Product hierarchy no. *				Part no.	SBU	Type / Description	Customer part no.
SBU	PG	PUG	Type				
02	007	043	0000002406	See list below	Appliance outlet for cable 16A 70°	0104U

Change of approval and rating markings on the moulding body.

Product Change Notification					0104U Change of inscription		
owner	creation date	release date	released by	change order no	rev	page	D10-042-125
sariogar	09.01.2020	27.02.2020	muehlema	2017620	A	1 of 2

Old product appearance		New product appearance

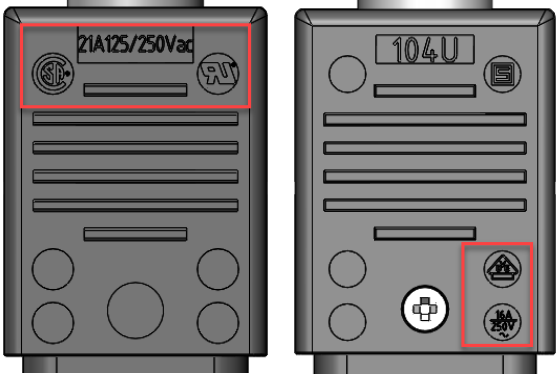
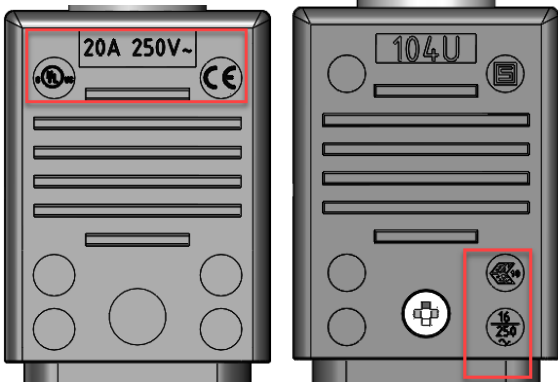
- Approvals CSA, UR, 21A125/250Vac, VDE and 16A/250V~ replaced to cULus, CE, 20A 250V~, ENEC10 and 16/250~
- Label ENEC10 and cULus added.
